Subject ▶ Change of Bearing.

For Models ▶ 9523NB, 9524NB, 9525NB

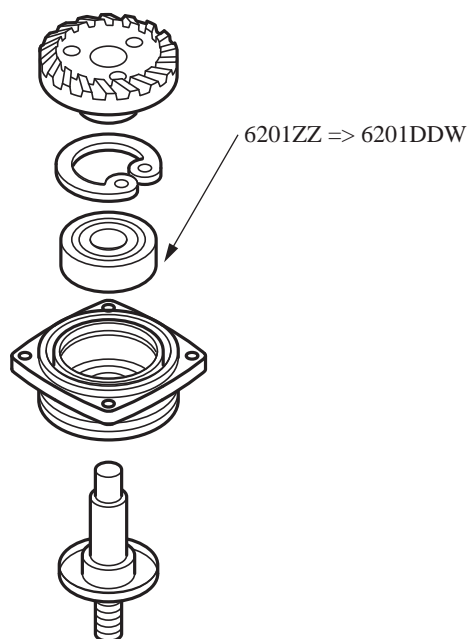
Description ▶ As illustrated below, Ball Bearings has been changed, for improvement in endurance.
6201ZZ (seal color: Silver) => 6201DDW (seal color: Green)

Item No.	Current part		Q'ty	I/C	New part		Q'ty	Note
39	Ball Bearing 6201ZZ 211107-9		1	<=	Ball Bearing 6201DDW 211129-9		1
